Def Item 1 REFERENCE NO - 21/504571/FULL

Demolition of existing property and erection of 2no. five bedroom dwellings with associated parking and private amenity space as amended by drawing no's. 21.29_PL_11 Rev A, 21.29_PL_12 Rev B, 21.29_PL13 Rev B, 21.29_PL14 Rev A and 21.29_PL_20.

ADDRESS Greystone Bannister Hill Borden ME9 8HU

UPDATE FOR MEMBERS ON HIGHWAY MATTERS

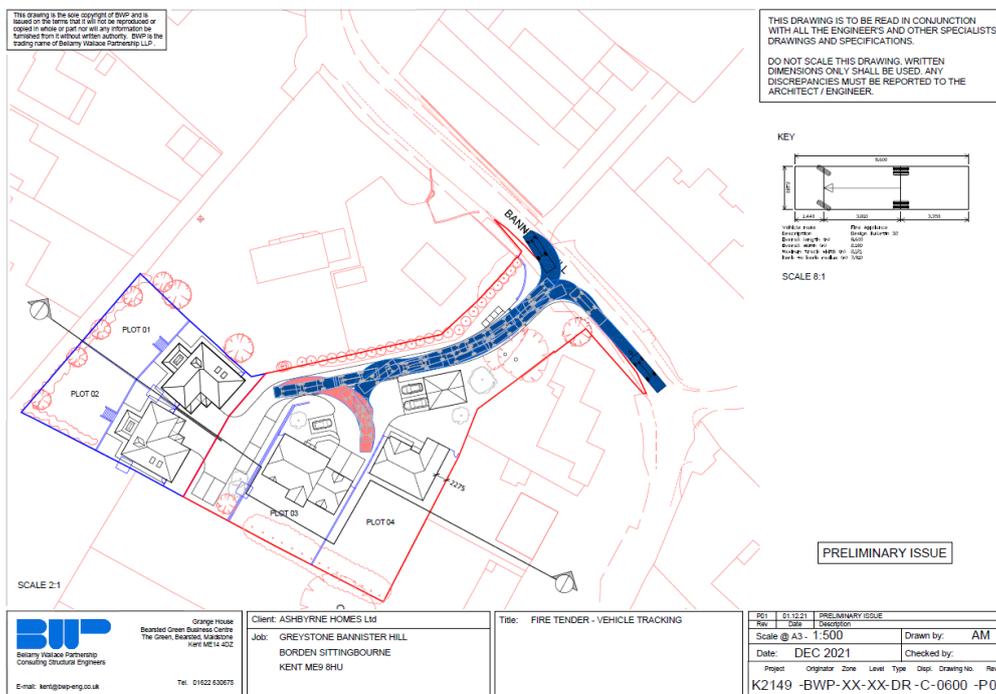
1. A review of the visibility splays at the site access confirming suitable visibility can be achieved and how it will be always maintained.
2. Provide vehicle tracking demonstrating a fire tender vehicle can manoeuvre using the proposed turning head and access and egress the site in a forward direction.
3. Demonstrate suitability of the proposed garages in accommodating required provisions. This should be confirmed so that the development parking requirements can be determined in line with SBC parking standards.
4. Confirmation of visitor parking provisions for the site.
5. Provide a tracking assessment demonstrating vehicles can manoeuvre into the parking bays identified in the review, notably to the east of Plots 1 and 2.

Please see the images attached showing both visibility splays. You will note the image facing north-west up Bannister Hill shows no overgrown vegetation. Our client has agreed with KCC an approach to replanting the verge which will not impinge on the visibility splays agreed under application 20/500051*. Under that application it has been agreed that the entrance to the site will be widened to 4.8m and the width will be extended into the site by 10m. This will mean that the wall shown in the attached images will be removed and the soil regraded to ensure that the visibility splays previously agreed are maintained.

*I have sought clarification on this point and the agent has confirmed that was meant to indicate that any new planting on the verge to the left of the access will be low level planting below the sightline level of 0.6m high; and he has confirmed that the existing wall is to be removed to widen the access.

The proposed means of maintaining adequate visibility splays by removing existing vegetation in addition to the removal of the wall is acceptable.
